3.3.3 London Borough of Hillingdon - Pre-app 3 - 24th March 2023

3.3.4 London Borough of Hillingdon - Pre-app 4 - 19th August 2024

3.3.5 London Borough of Hillingdon - Pre-app 5 - 21st July 2025

3.3.6 GLA Pre-App - 13th August 2025

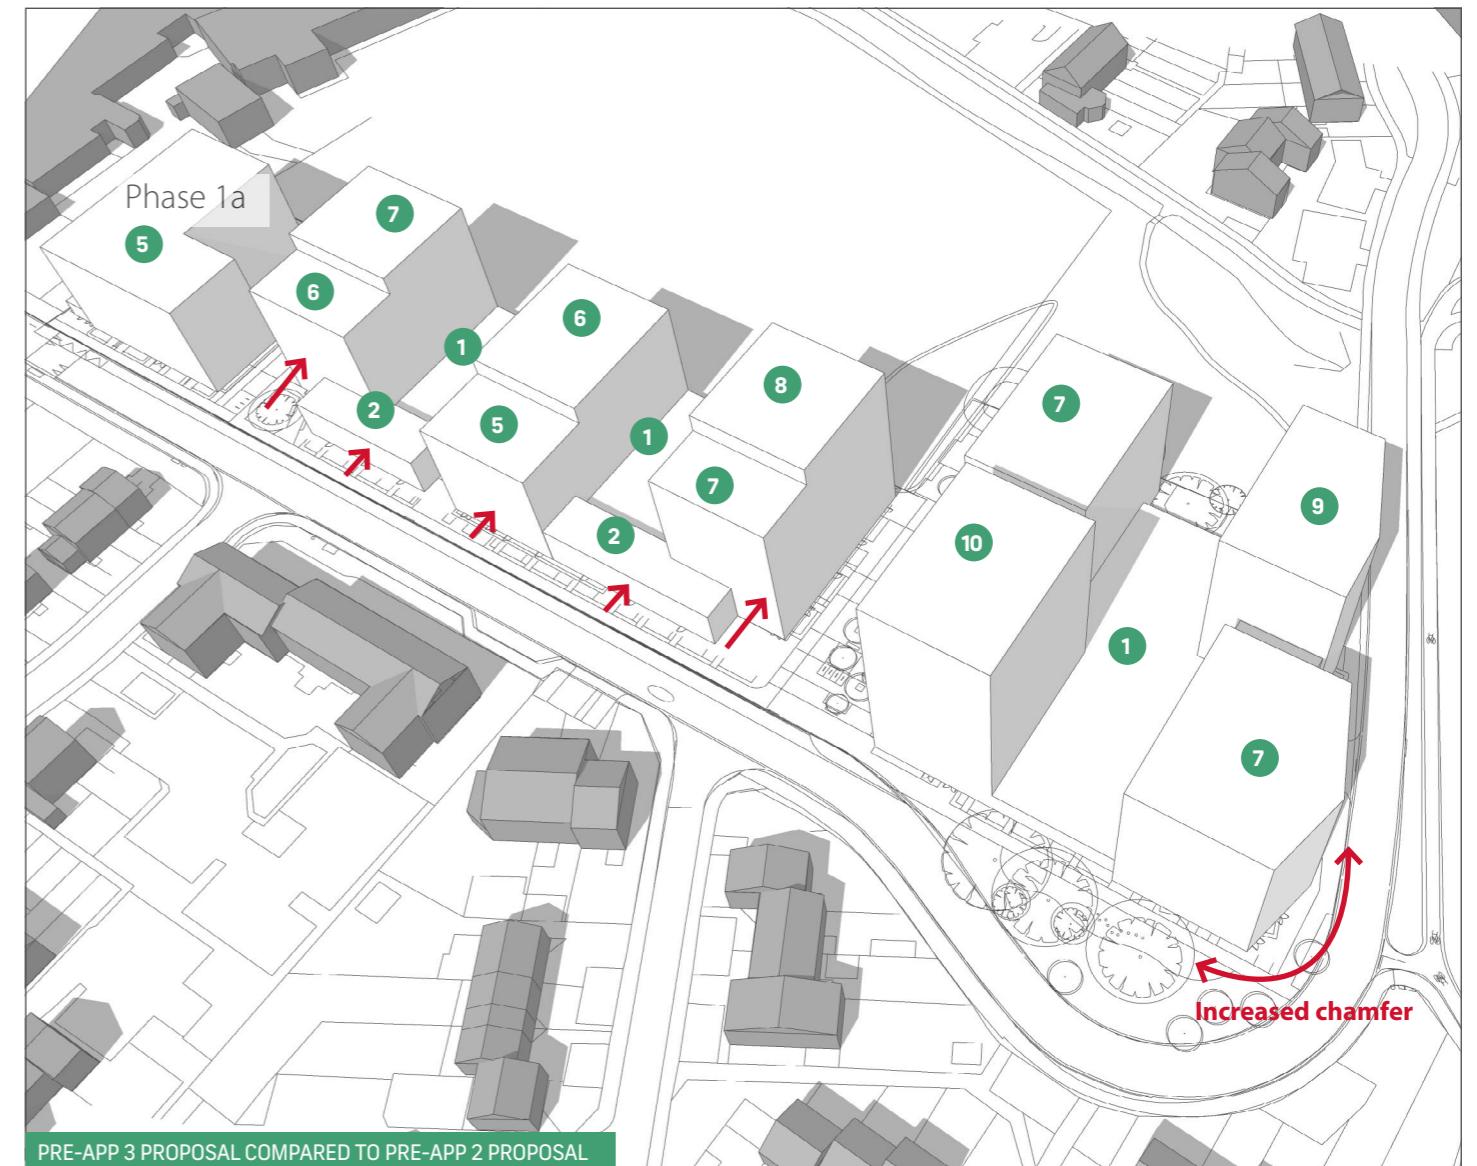
- Single-storey height variations across the middle phase will not be perceptible or lead to a varied skyline.
- An alternative treatment for the southeast corner building in phase 1B should be considered (facing Abbotswood Way).
- Active frontages should be more carefully considered along north and east side of phase 1B
- Double height lobby should be considered for tallest building.

- Check the calculation for play space and external amenity space.

- Phase 2 building line pushed back based on Pre-app 02 comments
- Phase 1b corner updated based on Pre-app 02 comments
- No change to building height

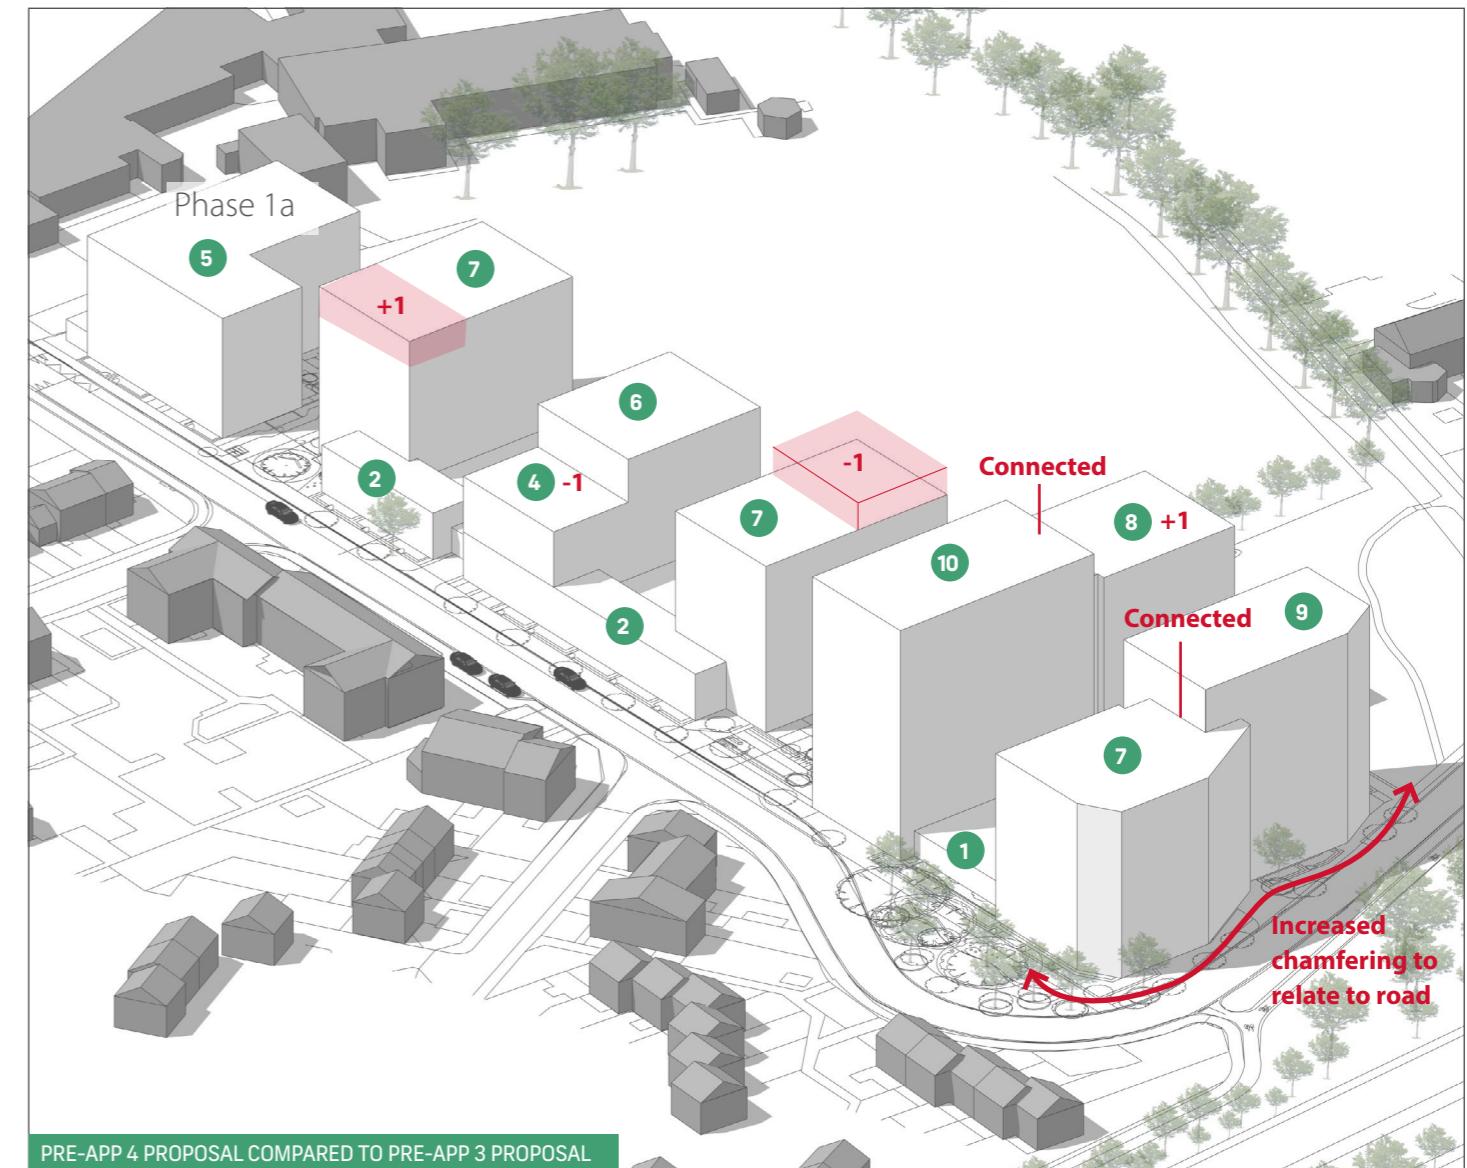
- Uplift in density is accepted in principle given the planned improvements to local transport connections and the encouragement for design led densification in the London Plan and NPPF.
- Detailed calculations on play space, communal amenity, private amenity and views required to demonstrate the increase in density can be supported comfortably on the Site.

- The design approach to shift the ten-storey taller building element towards Avondale Drive was discussed and in principle accepted.
- Officers welcomed the varying building height along Avondale Drive and the separation distance between blocks appears acceptable in principle

- Concerns were raised over how the proposed development would interact with the public realm towards the north side at Hitherbroom Park and how the layout would respond to the open green spaces at the playing fields.

- The continuous and considerable building frontage along Avondale Drive should be acknowledged and mitigated.
- The proposed chamfered corner at Avondale Drive is welcomed. However, the prominence of the corner can be further articulated by materials, slightly lower building height and additional glazing to reinforce visual interest.

- The perception from street level at Avondale Drive at the east side of the site should be tested further, considering the limited width of the footpath and the absence of soft landscaping along this side.

- Detailed calculations on play space, communal amenity space, and private amenity space should be provided

- Concerns with regards to the number of units per core should be addressed, as these exceed the minimum requirement of eight units, set out by GLA guidance.
- Every effort should be taken to move the entrances/cores further to the road frontage to reduce impact on privacy of the ground floor units and to respond to a legible perception of street hierarchy.
- Details with regards to refuse collection, servicing arrangements and emergency routes should be provided, to ensure that these operational requirements have no conflict with amenity spaces.
- The introduction of a social component and community infrastructure element should also be considered
- The units at first floor level overlooking the podiums should contain defensible spaces, considering that these windows would be directly overlooked by the communal amenity areas
- Details of wheelchair accessible units should be provided

- Car Parking Management Scheme and Transport Assessment would be required for further review
- No details of cycle parking stores for the different building elements have been presented at this stage but these should be conceived to meet regional standards
- In terms of refuse, waste collection distances between a designated bin store and a refuse vehicle should not exceed 10m to comply with waste collection standards (with carrying distances from each residential unit to a storage area not exceeding a distance of 30 metres)
- Details showing existing and proposed car parking spaces would be required.

- Steps in massing adjusted to create a more varied skyline as per comments. Also simplifying blocks which are set back from the road
- Angle of key chamfered corner adjusted closer to 45 degrees to suit long range views
- 2nd staircase added to all blocks over 6 storeys to respond to legislative changes
- Tenure changes

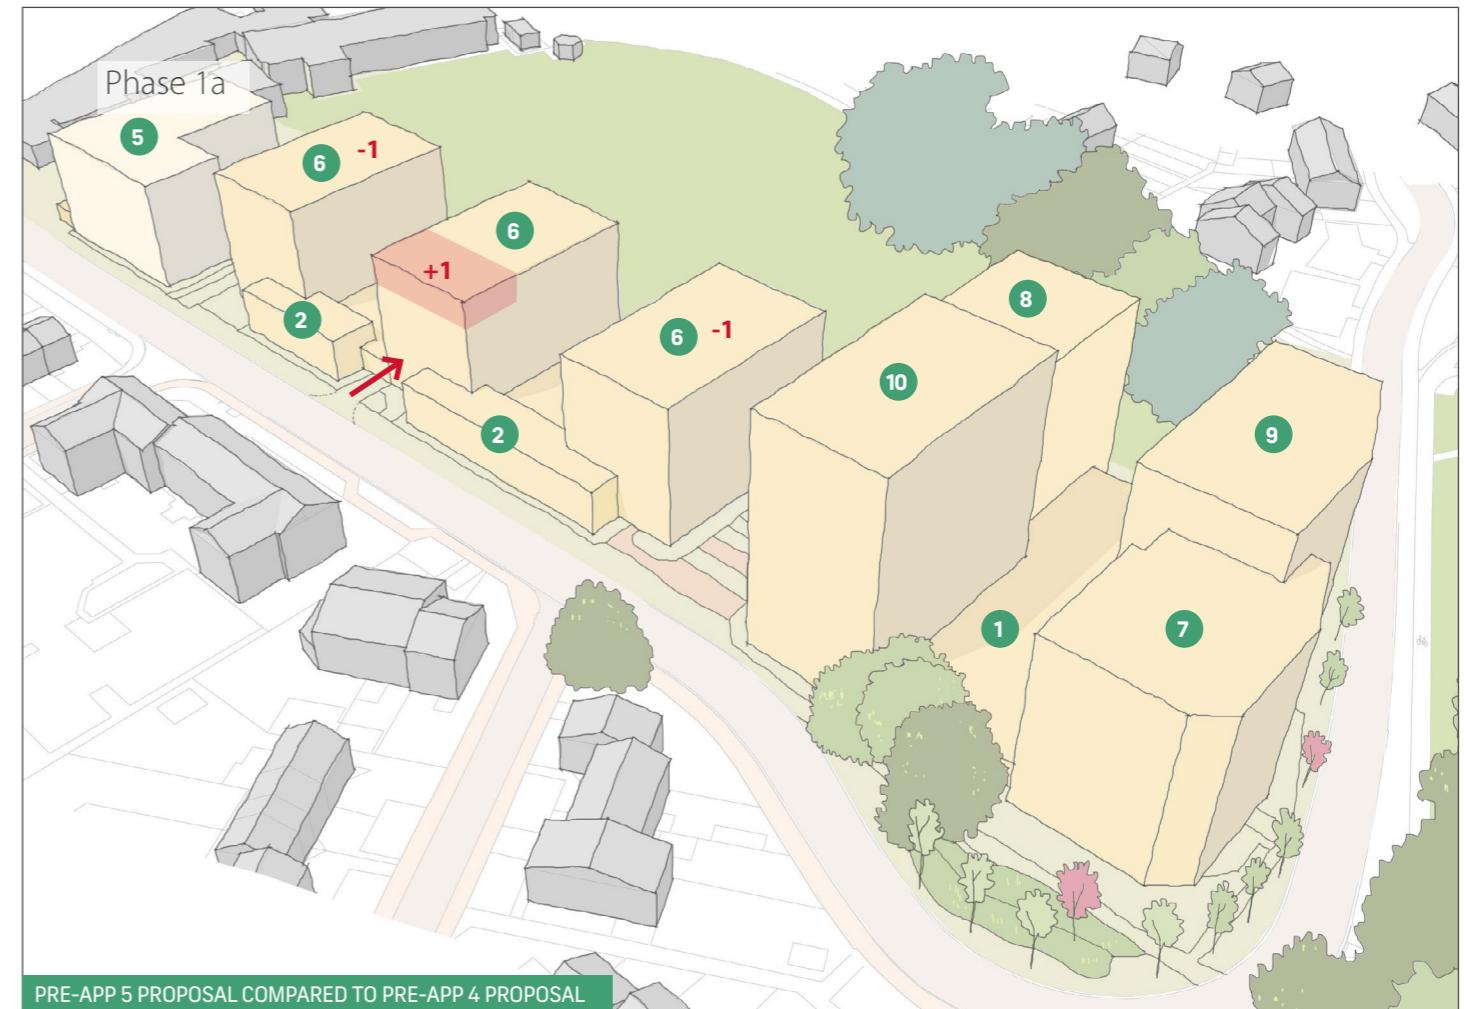
- The design amendments are considered an enhancement on the previous proposals presented at pre-app 4 stage in terms of the approach to massing and allow additional separation between the new buildings and dwellings opposite, which is welcomed. Based on the presented plans there are no fundamental concerns in terms of the general design approach.
- Clarification needed on the criteria used to determine Dual Aspect percentages
- More technical details expected in next pre-app and a greater focus on the RMA details

- DLSL Impact of proposal on park and existing trees to be tested

- Location of 'play on the way' space along connection to Hitherbroom Park to be explored further. Suggestion that this could be more southerly to improve DLSL, subject to servicing/emergency access requirements. Ensure public access
- Provide dimensioned sections of planting/landscaping within the footpath
- Prove concept of tree planting/raised beds on podium with precedents, typical details and parameters
- More details on boundary treatments to be provided
- Precedent examples of rain garden and 'play on the way'

- Set back block C further from the street creating alignment in phase 2 where only the duplexes sit aligned with phase 1a, the mid-rise blocks are set back. Pocket of space at the front entrance
- Set back block F further from the street to give more space for defensible space and planting
- Set back phase 1b from the park edge
- Reduced the massing of phase 2 to reduce the canyon effect between blocks D and E and limit the number of HRBs
- Tenure changes
- Uplift on number of overall homes
- working together requested
- Precedent examples of SUDs and podium tree planting requested

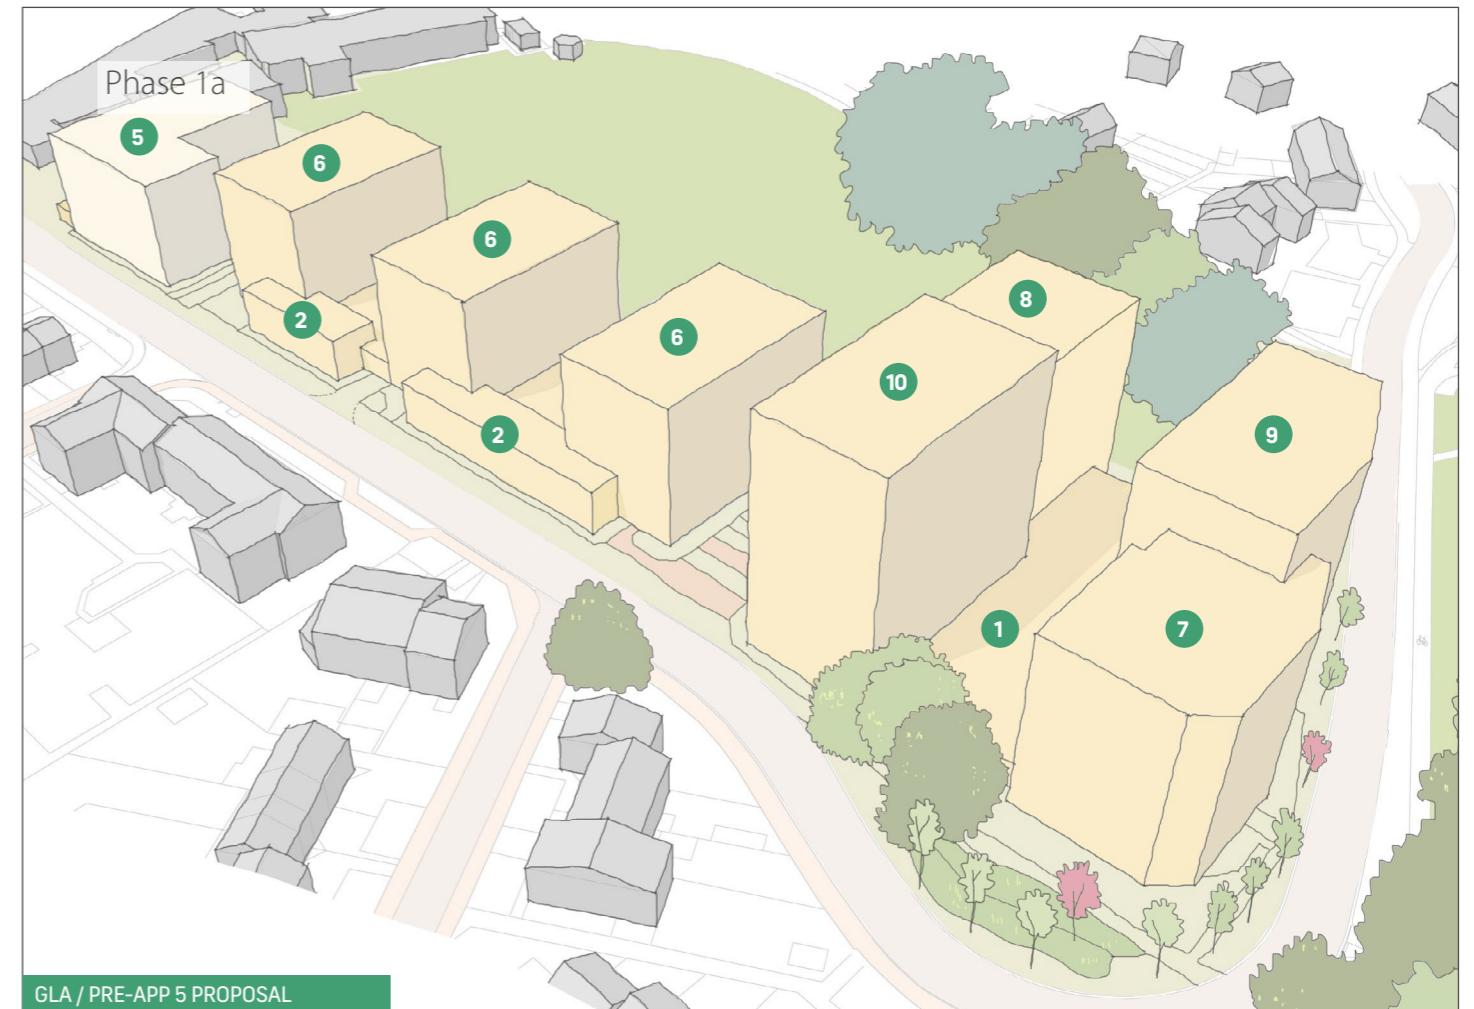
- The proposed layout of the Phase 2 blocks is supported. The long street frontage to Avondale Drive is active and articulated, with homes 'wrapping' the podium edge on the street side. The podium wall facing the school fields should be designed to provide interest when viewed from the school.
- The proposed permeability through to Hitherbroom Park is welcomed.
- The principle of a podium block for Phase 1B is acceptable and the layout indicates a podium edge wrapped by homes and active uses. This is welcomed
- Throughout the proposals, street level activation of public routes and spaces is provided; this is supported. As with the previous site, additional emphasis on the entrances to create greater street presence should be considered.

- Location of 10 storey block was contested between LBH and the GLA. The GLA suggested the tallest element be relocated back to the North of block E. Subsequent discussions with LBH at the 6th pre-application meeting reiterated LBH and the applicant teams' preference for the tallest element to remain in its proposed position to the South.
- The Phase 2 blocks provide a good percentage of dual aspect homes, have fewer than 8 homes per core and have windows to the cores to provide daylight and views out. This is all welcomed and strongly supported. The residential quality of Phase 1B could be improved by reducing the reliance on long double loaded corridors and introducing daylight to these.

- Consideration should be given to how the public realm will feel during different times of the day, ensuring that the design and management makes such spaces, attractive, safe and perceived to be safe, by all at all times. Particular care should be given to the entrance with the adjoining park.
- The creation of a pedestrianised street to improve the site's connection to the adjoining park is welcomed.
- Make sure areas of public realm support the local community, not just residents

3.3.7 London Borough of Hillingdon - Pre-app 6 - 29th August 2025

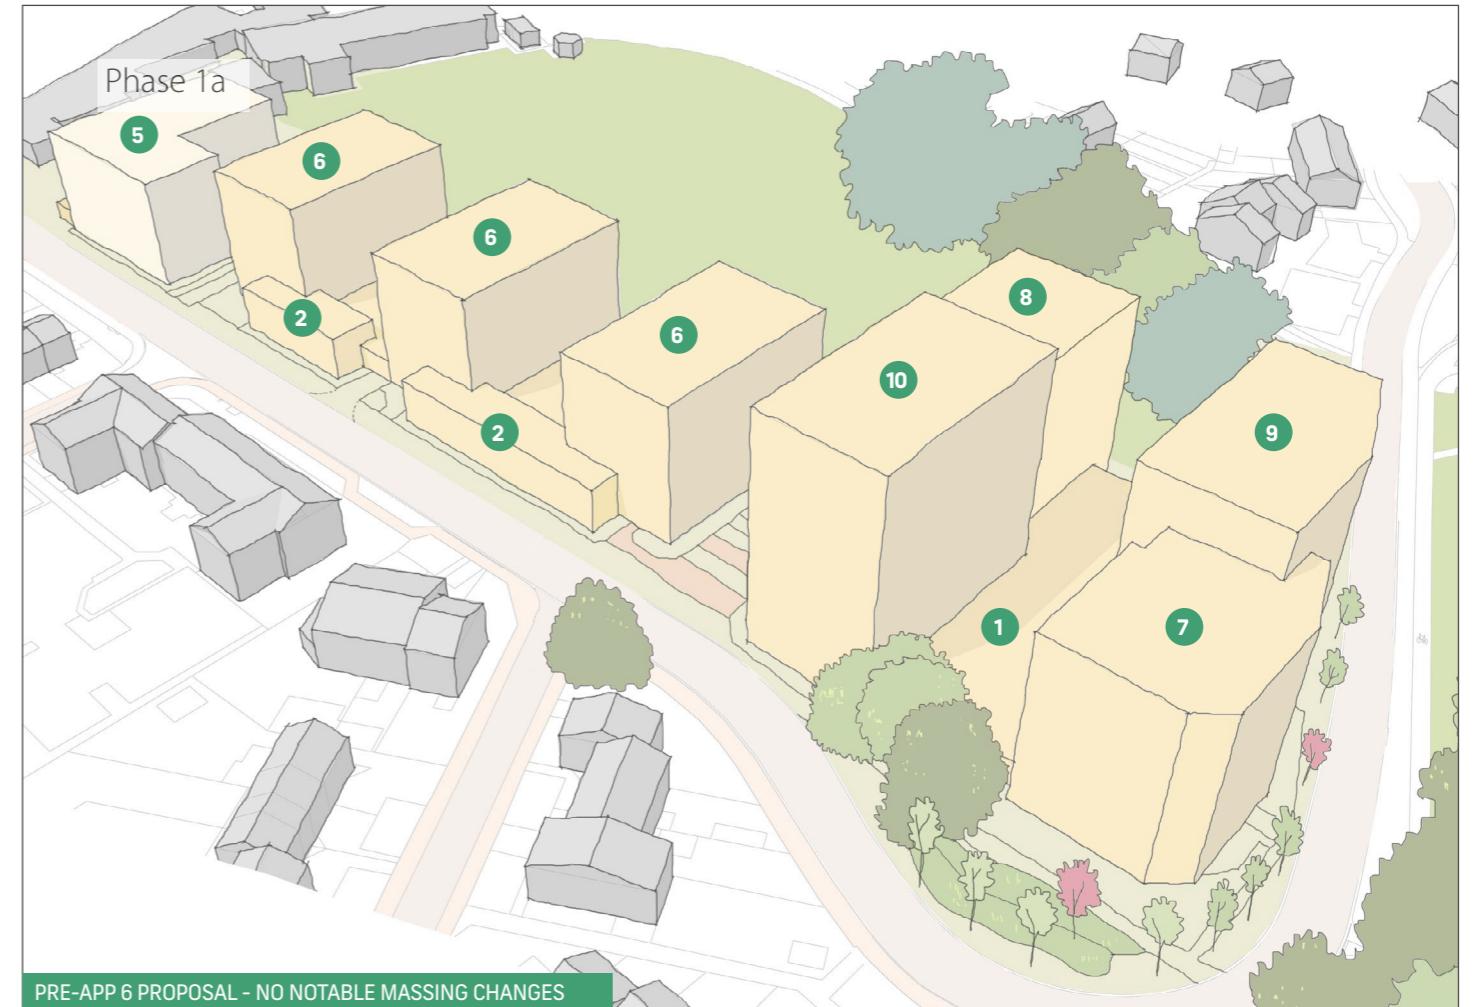
- Location of marker building is supported.
- Massing and storey heights are supported.
- Relocated play on the way landscape space well-received.
- Calculation of play space accepted in principle.
- Proposed parking ratio accepted.

- Play on the way landscape space moved South in masterplan to benefit from better daylight and greater sunlight
- Ground floor layout changes to accommodate design and consultant coordination
- Minor changes to accommodation mix
